City of Portland, Maine – Building or Use Permit Application 389 Congress Street, 04101, Tel: (207) 874-8703, FAX: 874-8716

HAYMAN RESIDENCE
REED AVENUE
PEAKS ISLAND, MAINE

BUILDING PERMIT REPORT

RE: Rail System at Hayman Residence on Peaks Island

FOOT OF STAIR PLAN AND ELEVATION

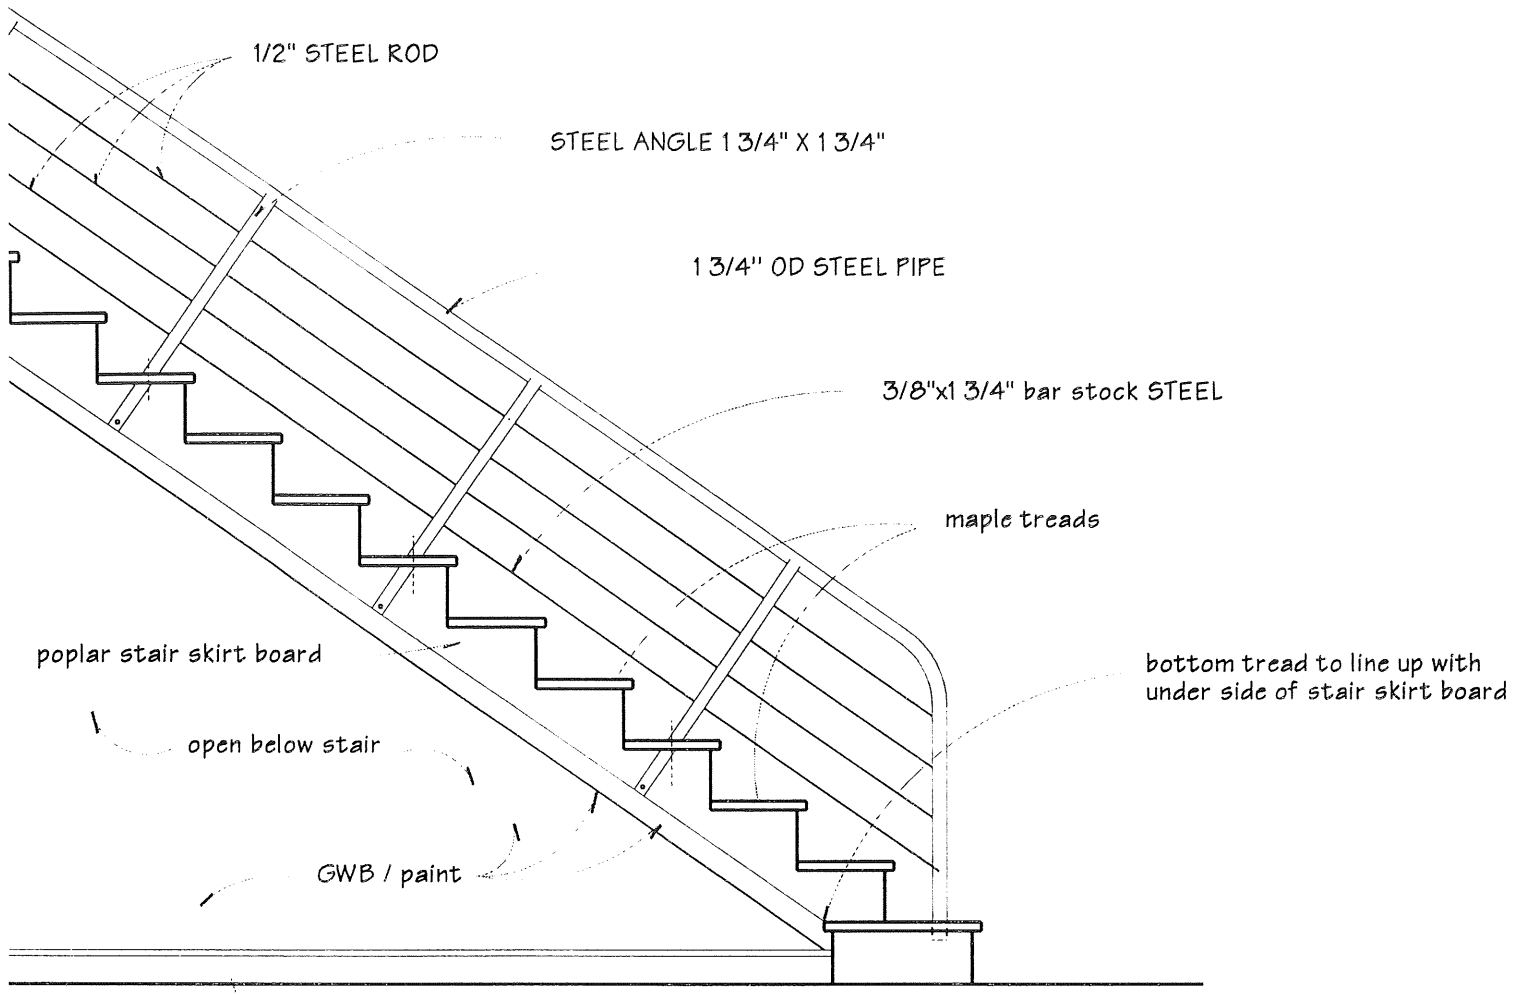
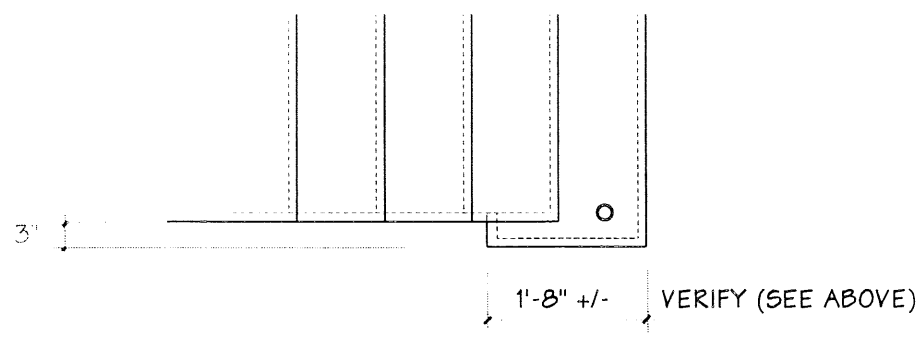
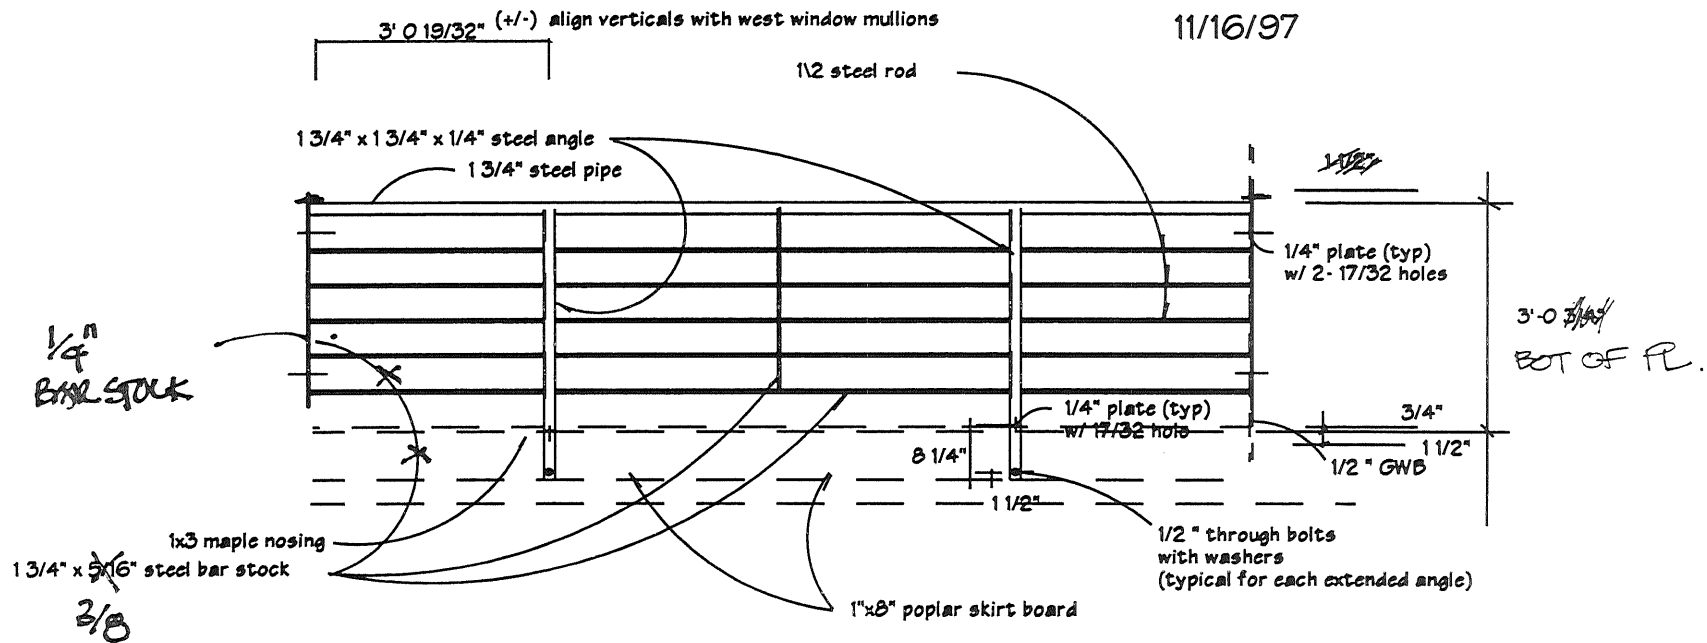
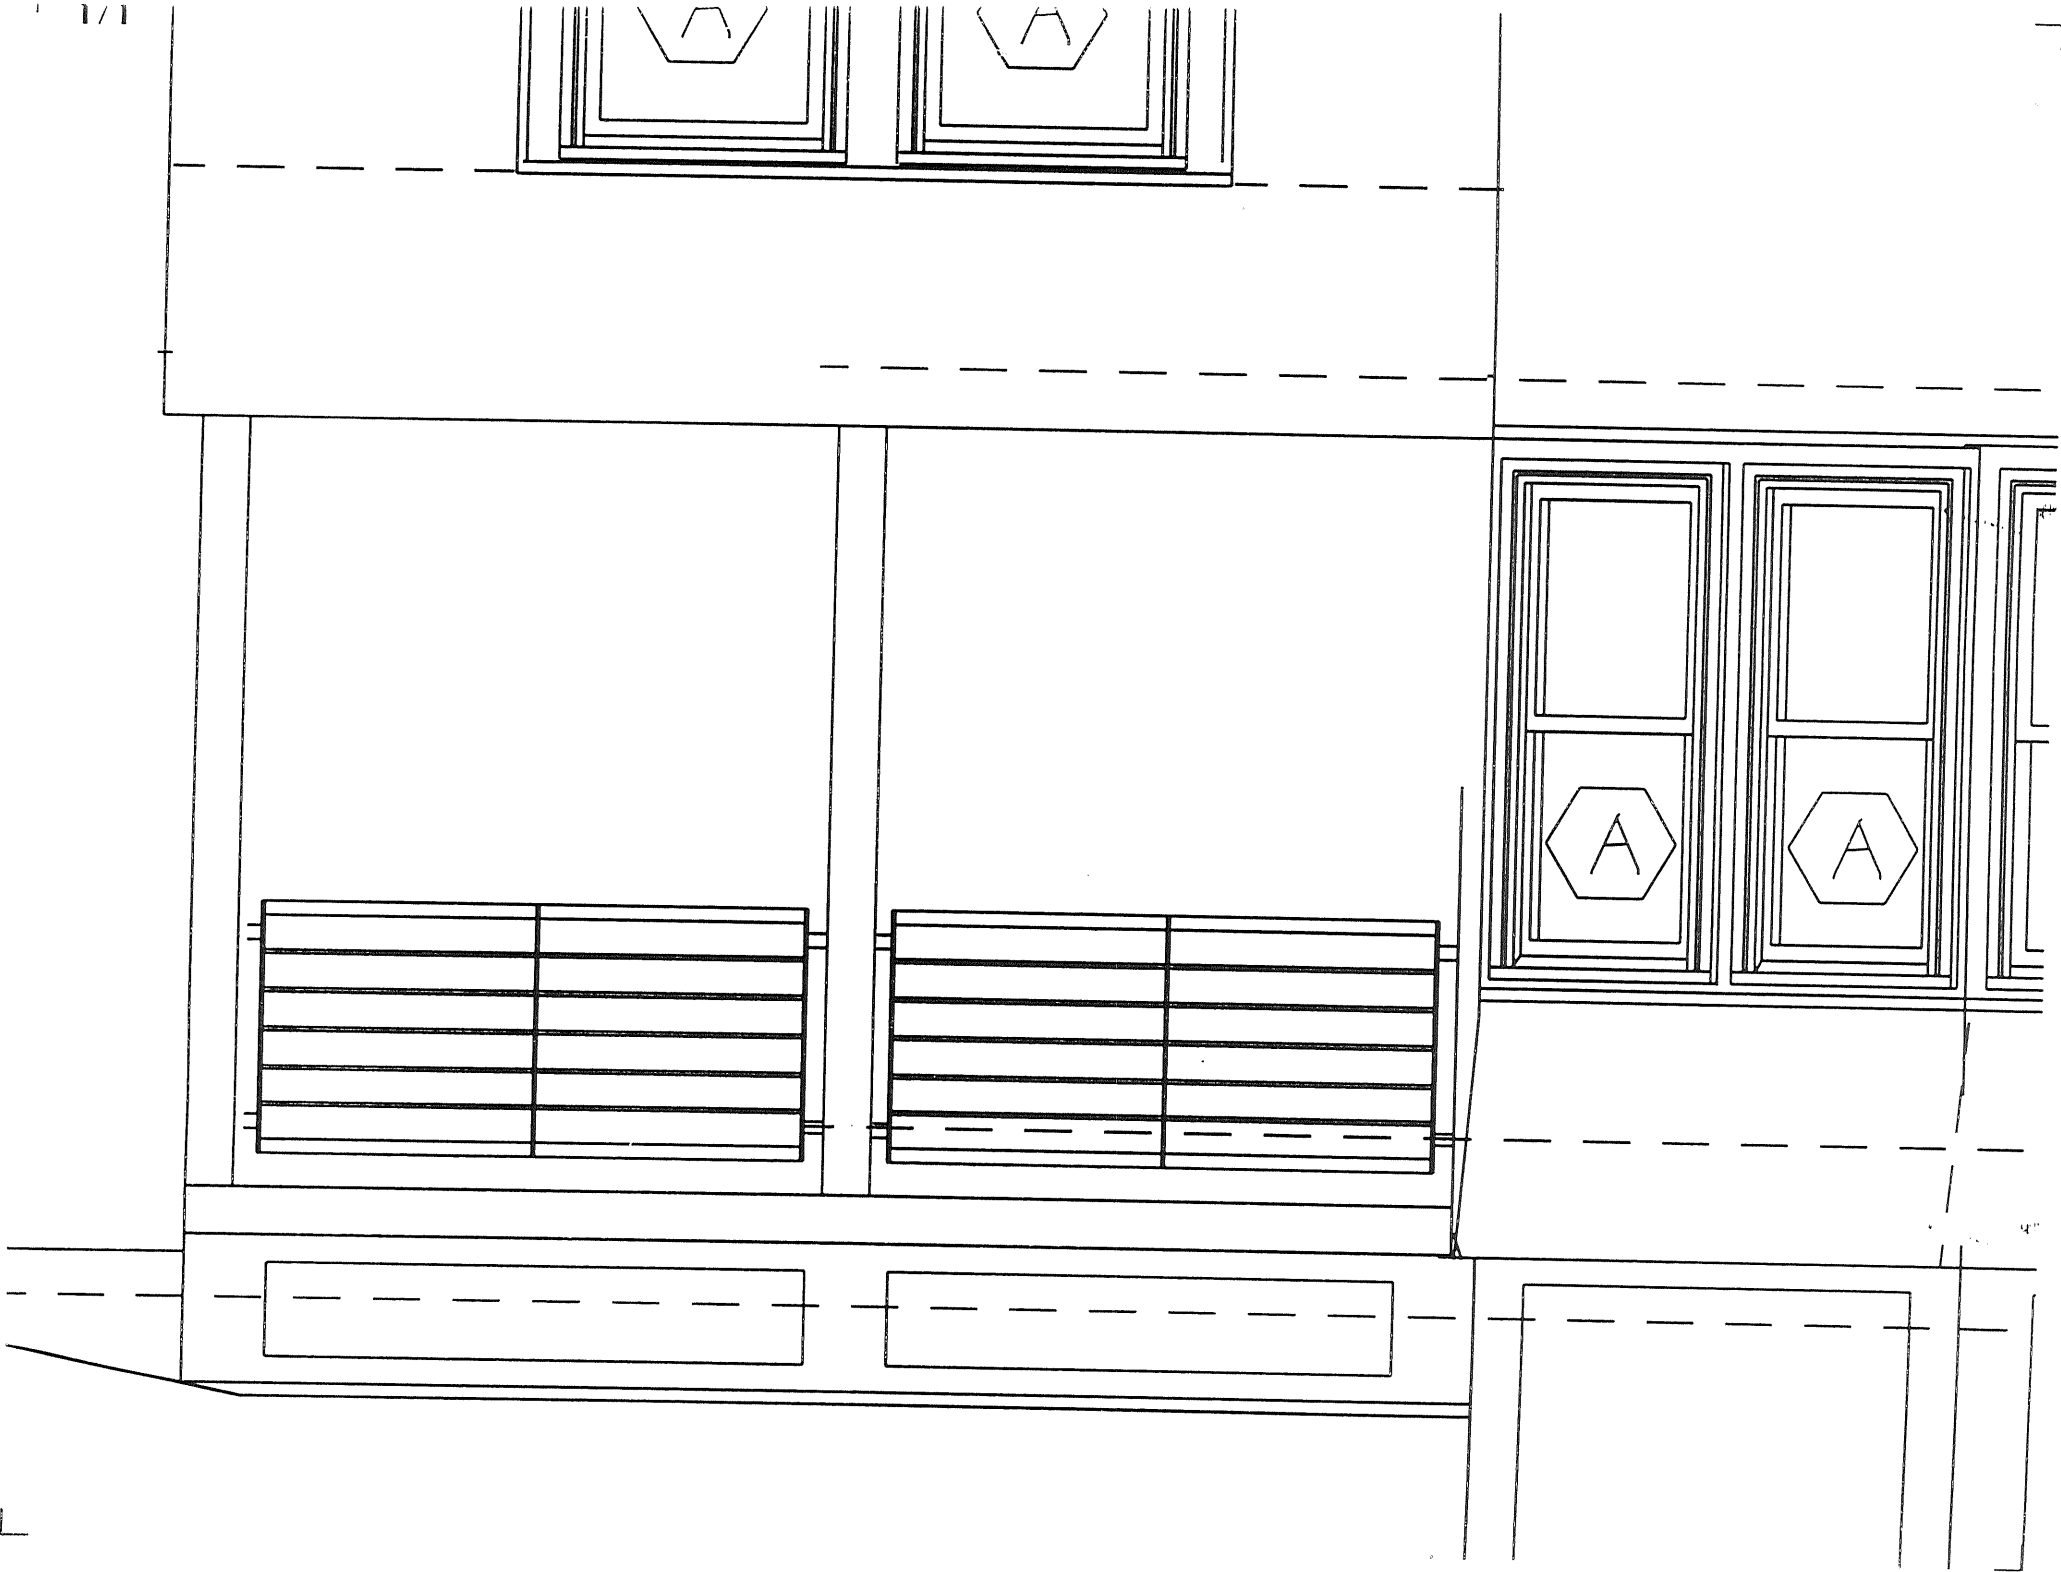
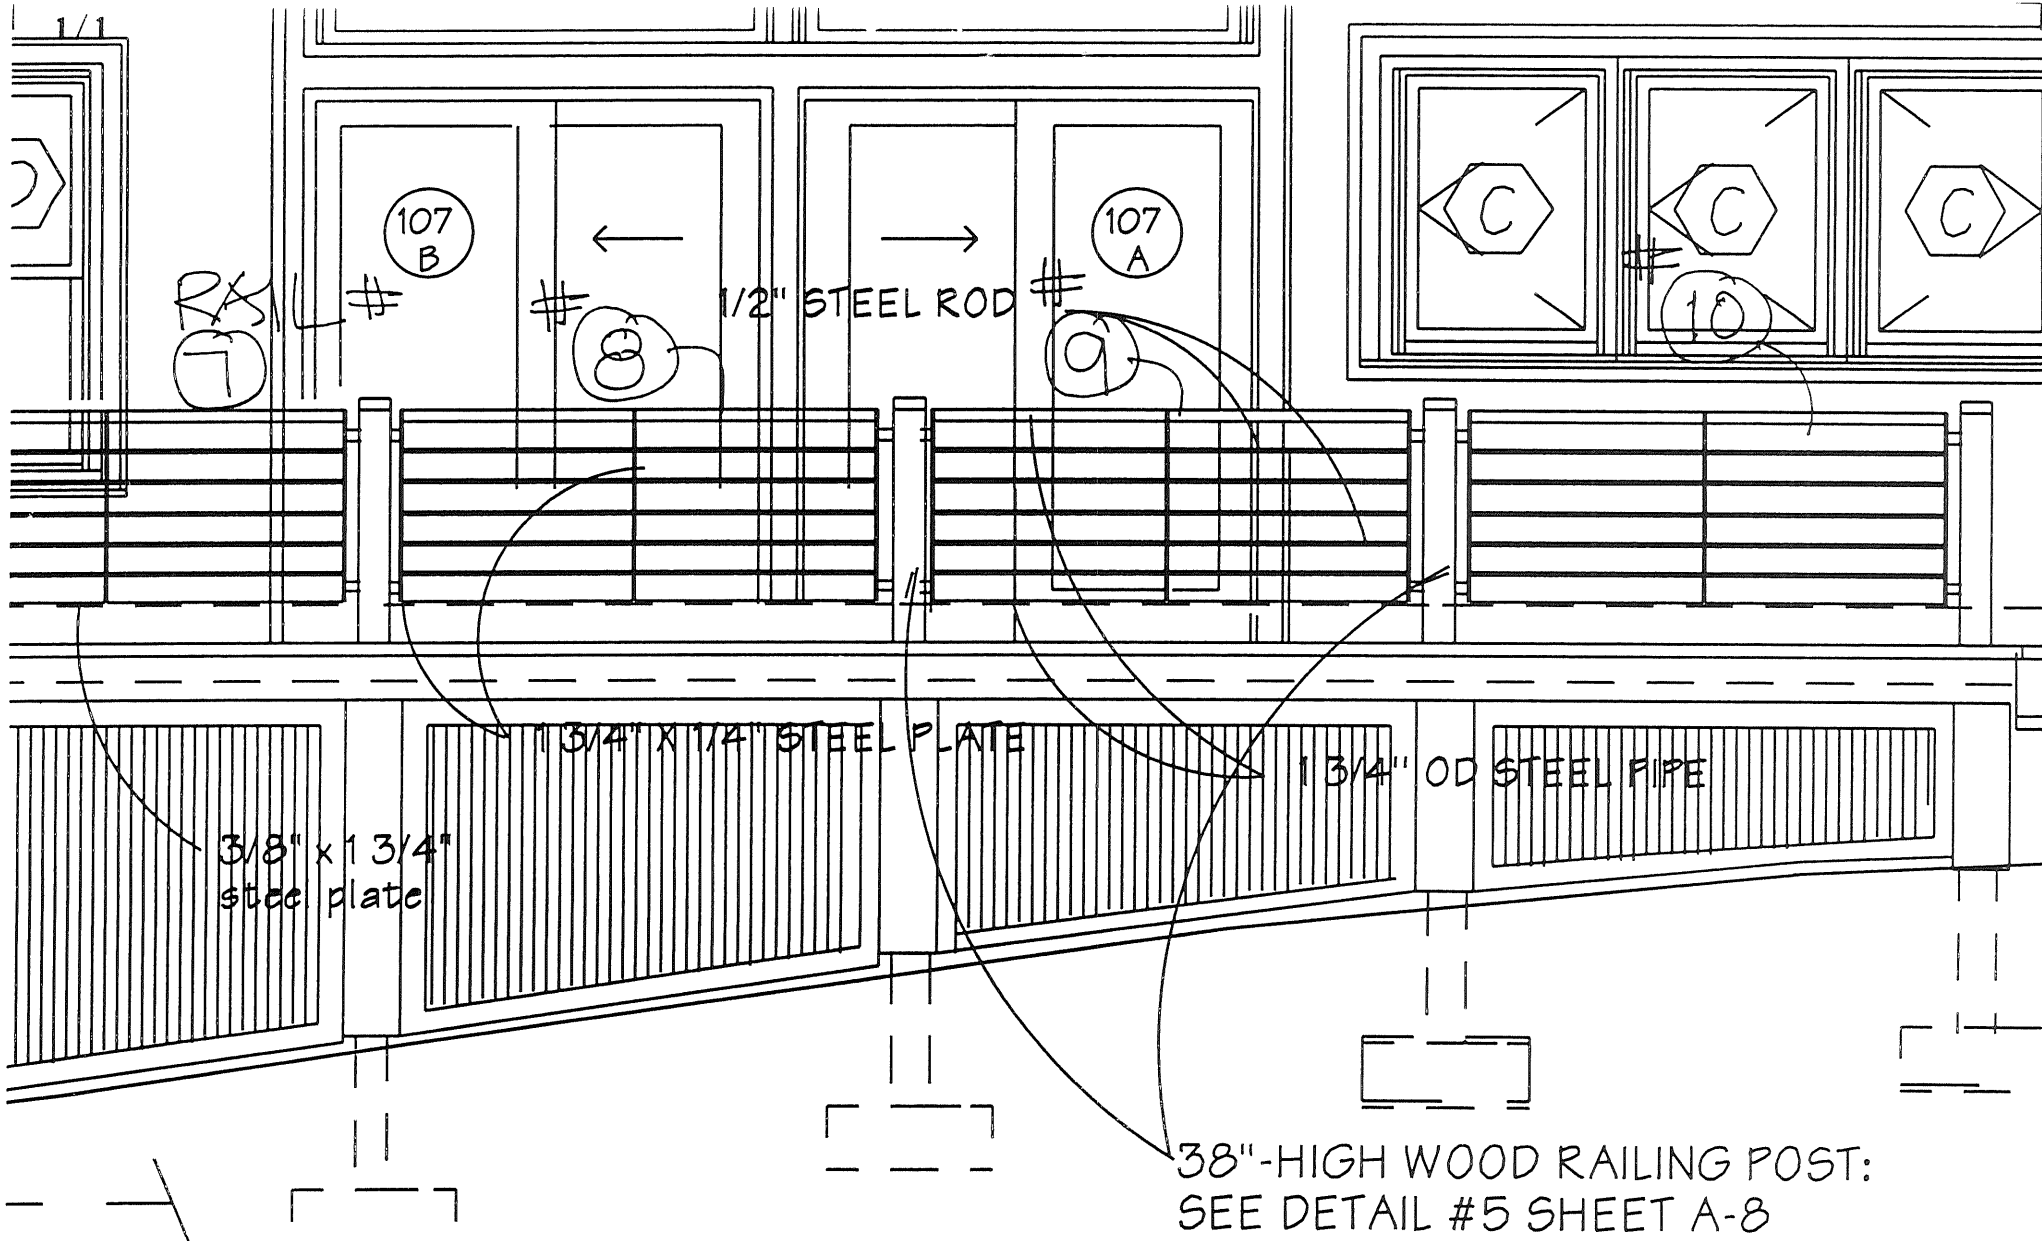
Liberties were taken during the design, that makes the hand rails and gard rails non-compliant with the 1996 BOca code. Sec 1021.3, BUT the rails do not effect the stair system structure, or its Fire performance. Therefor, with the understanding, if the stair rail system is redone it will meet present code standards.

Please find enclosed drawings from which the rail system at the Hayman Residence was constructed. As discussed with you and our clients, the architect is aware that liberties were taken during the design that technically make the rails non-compliant with the 1996 BOCA code.

I do however feel that the rails are extremely safe and will serve to protect vertical openings from mishaps by children of all ages as well as adults. The rails are extremely rugged and easily grasped. We feel the close spacing of the horizontals meets the spirit of the code. Given that this project is a private, single family home, the client and architect hereby formally request a waiver of the strict interpretation of the code and further request that a certificate of occupancy be issued.

I have reviewed, this plus seen the job well after completion. This work did not or does not meet the letter of the code as per section 1021.3, but the handrails does not affect the stair system structural or on its fire performance. Therefore, with the understanding as set forth and if the stair rail system is redone it will meet present code standards.
